## ERRATA

**Figure 7.30** Some possible locations for the organ in cruciform Roman Catholic and Protestant churches.

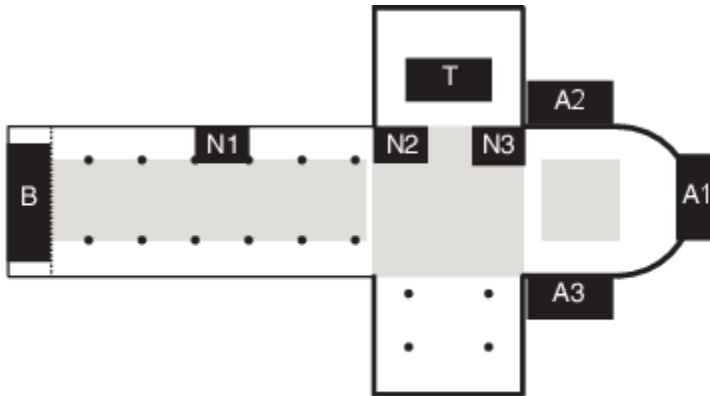
Page 113, Figure 7.30
